Case Number: PC 23-27

Description: Proposed single family dwelling on a steep slope

We have completed our review of the Steep Slope site plan for the proposed new home located at 5429 Franklin Road. Please see below for engineering comments.

DETAIL #2 - CONCRETE HEADWALL

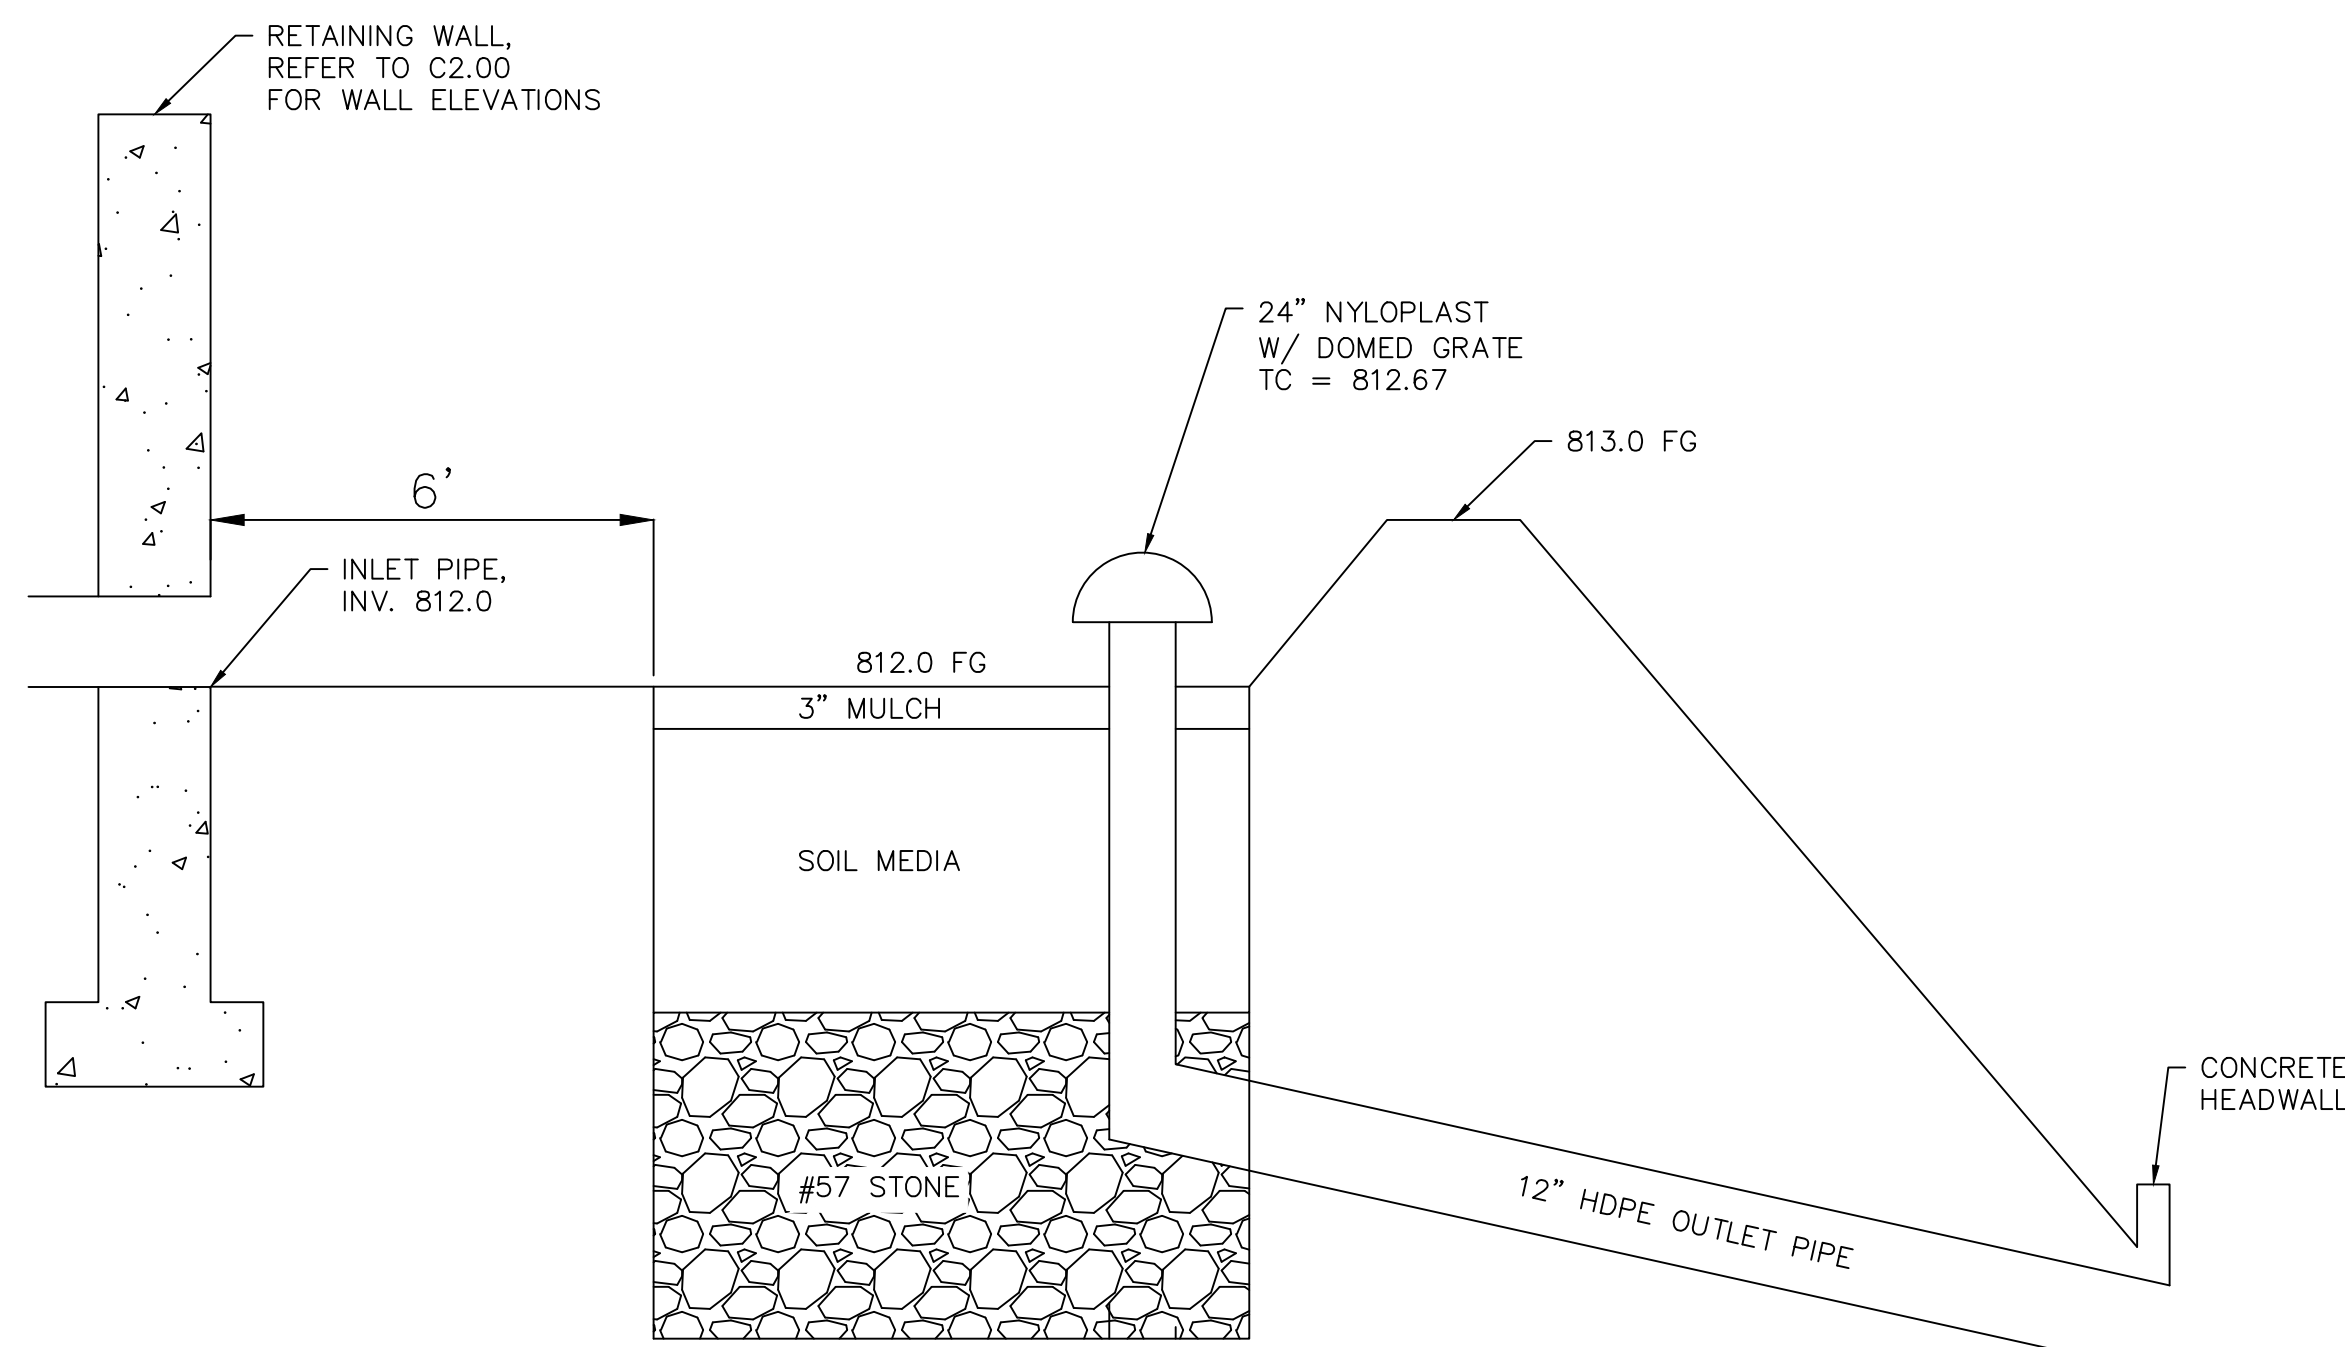
- a. Provided.
11. Where is the concrete headwall detail to be used? Show on plan.
 - a. Provided.
12. Provide routing for stormwater to get to rain garden

DETAIL #2 - CONCRETE HEADWALL

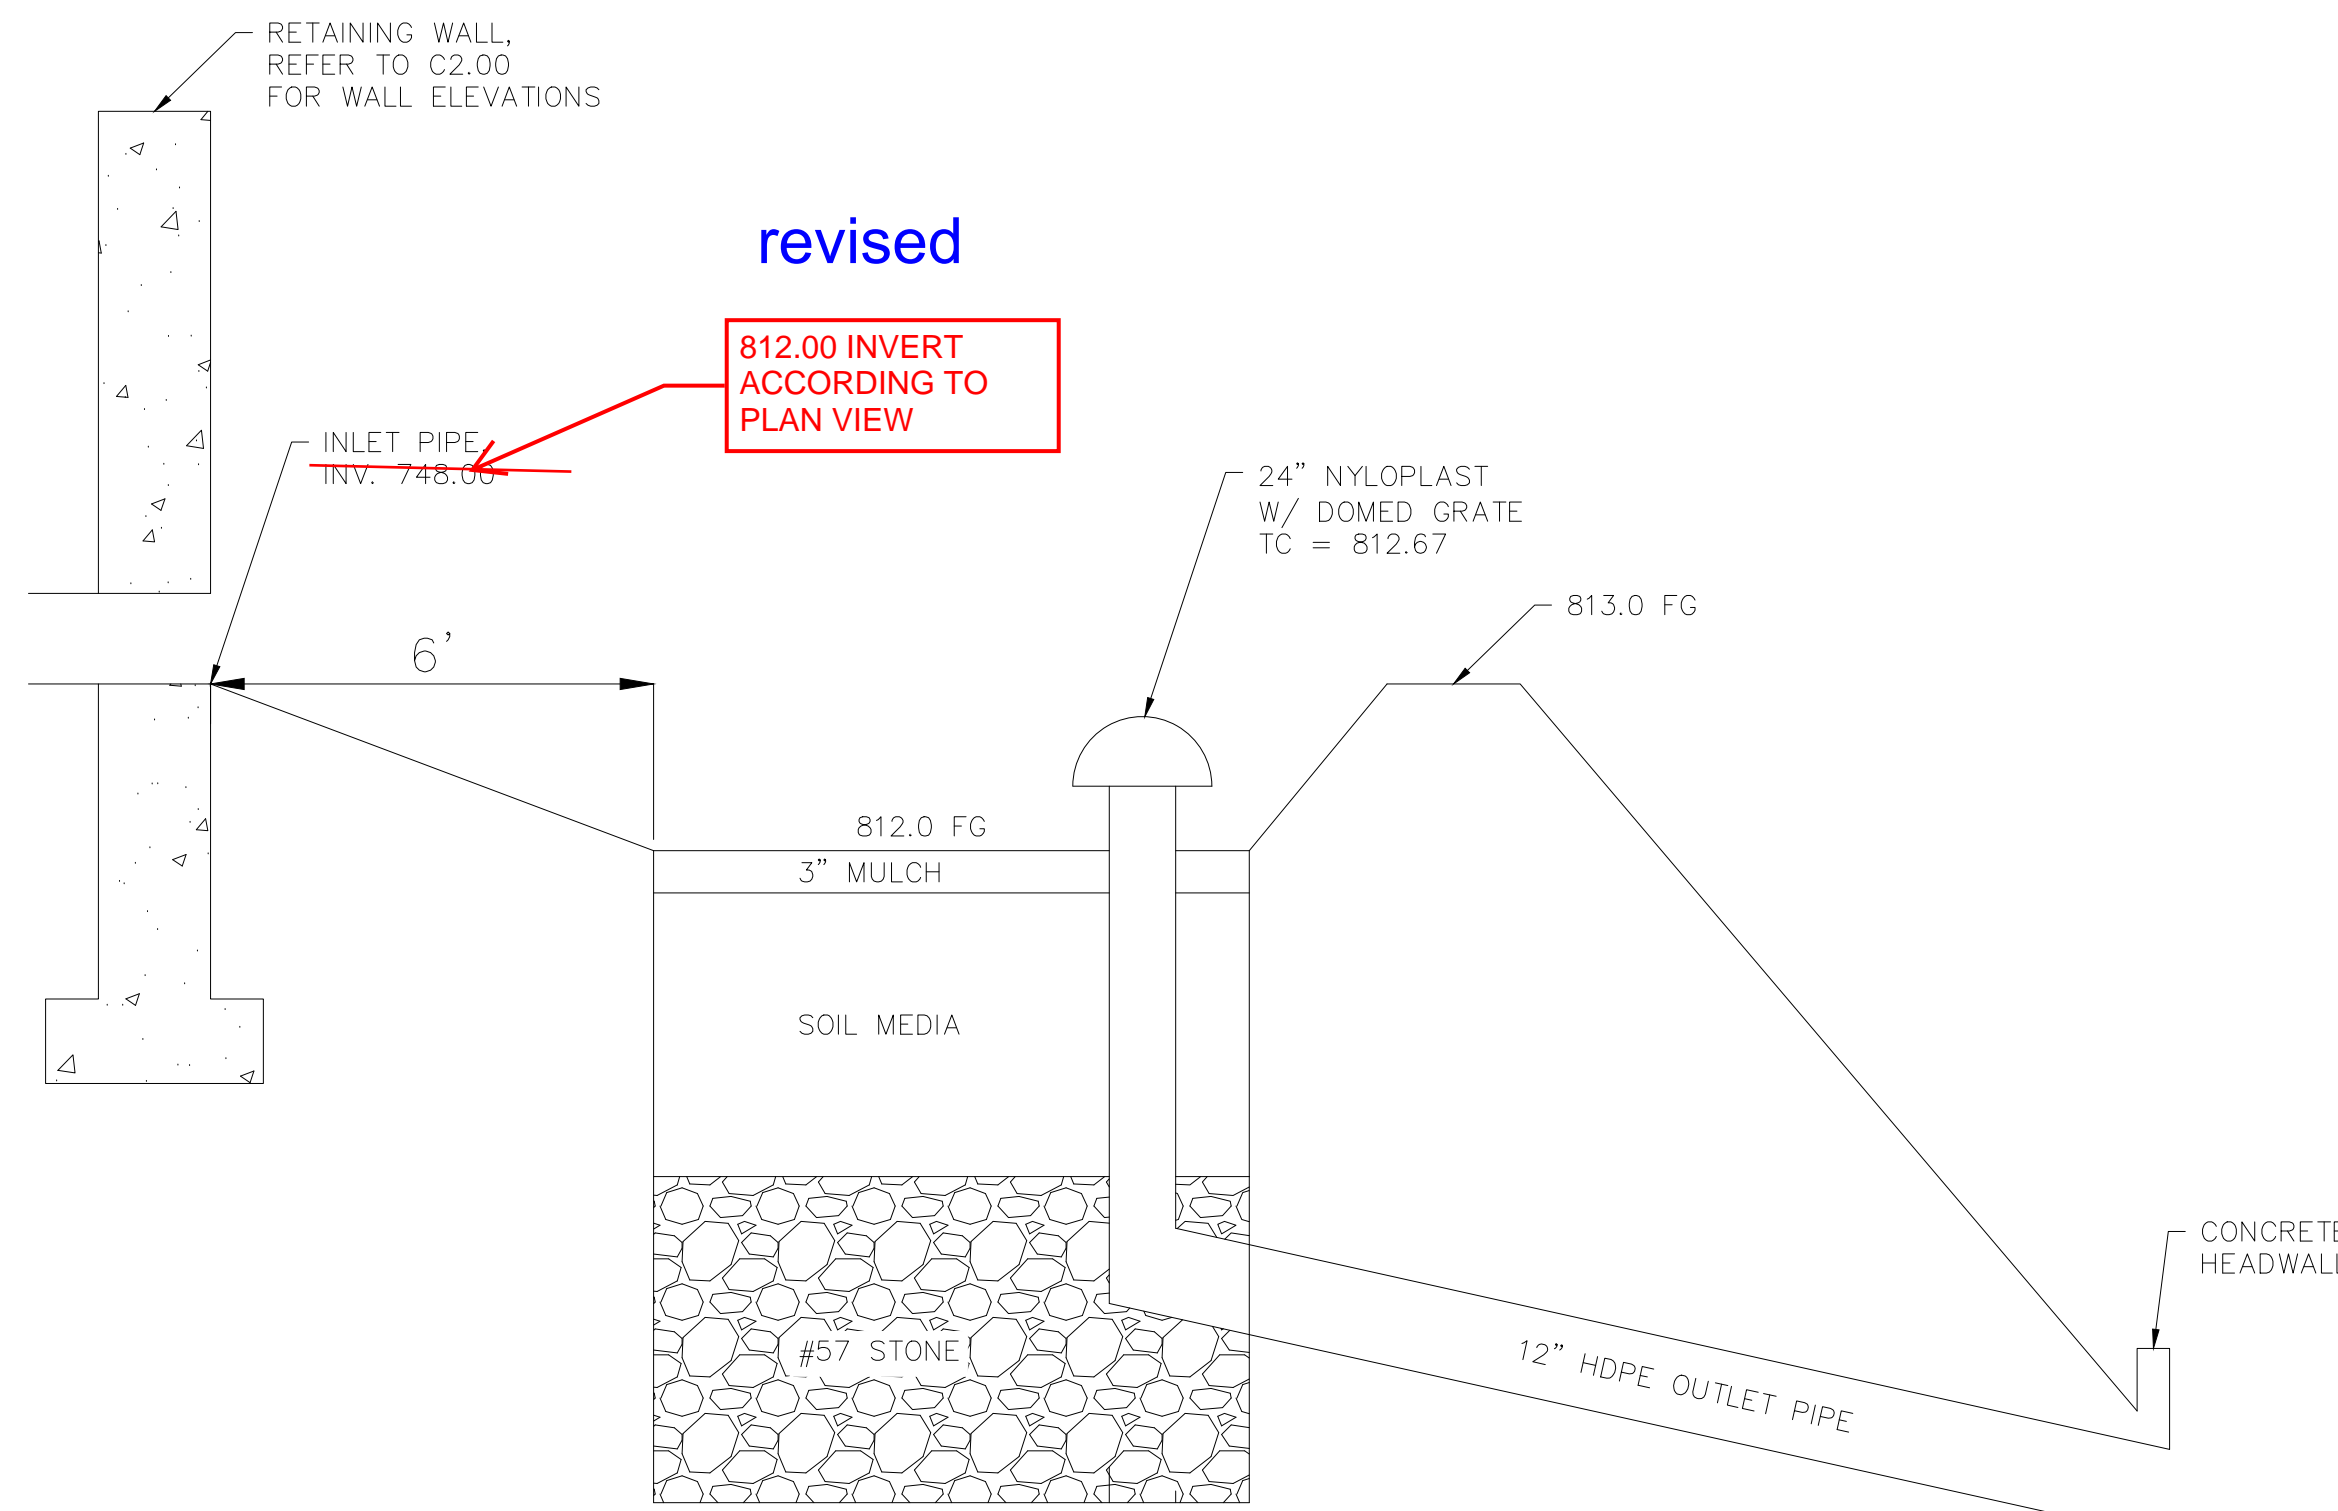
- a. **Provided.**
11. Where is the concrete headwall detail to be used? Show on plan.
 - a. Provided.
12. Provide routing for stormwater to get to rain garden
